CONDITIONAL APPROVAL
PLAN APPROVAL EXPIRES: 02/12/2017

Facility: 50271 AH STOCK MFG CORPORATION
 8402 CENTER RD
 NEWTON 53063
 Plan Type: Addition-Alteration; 1 Interior Fixture(s)

Object Type: Commercial Water Treatment Device Regulated Object ID No.: 1523407

QUADPLEX ARSENIC FILTER SYSTEM AH STOCK MANUFACTURING		
DWG # 79-ARSENIC CURTAIN-4 AH STOCK 2-6-15	dwg by: A,MAST	
Approved by Engineer:		A,MAST

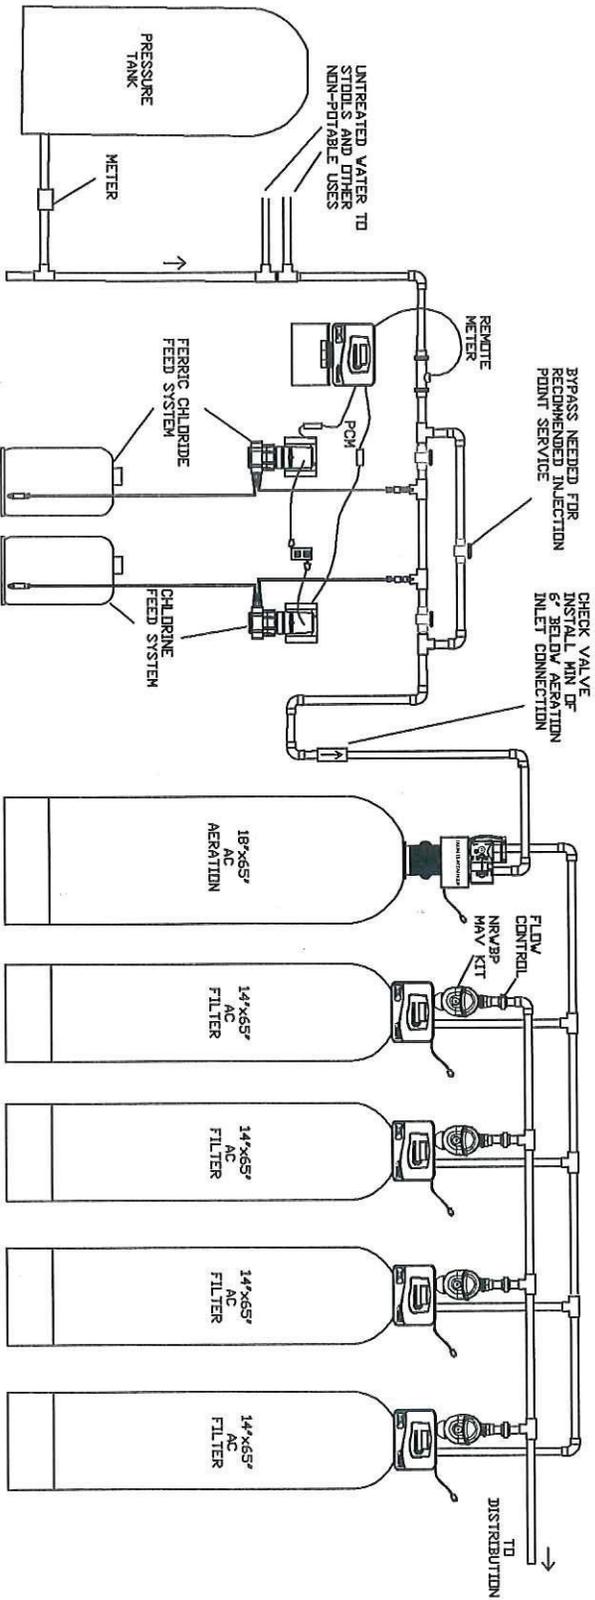
- The complete system is comprised of two chemical injection pumps, an 18-inch aeration tank followed by four AC-14 units installed in parallel via a balanced manifold; each with a restricted flow rate of 3.4 gpm x 4 = 13.6 gpm maximum flow rate. Of the two chemical injection pumps, one is injecting liquid chlorine (HOCl) to convert any trivalent arsenic (As^{+3}) present to pentavalent arsenic (As^{+5}); the second pump is injecting ferric chloride ($FeCl_3$) to support the desired coprecipitation reaction.

- All piping shall be labeled in accordance with Table 382.40-1a.
- The DWV system shall be properly sized to accept the additional loading from the four AC-14 units.

- The installation shall be performed by a properly licensed Wisconsin plumber.
- No bypass piping shall be installed serving the AC-14 devices. If a bypass is desired, then it must be of the locking type.
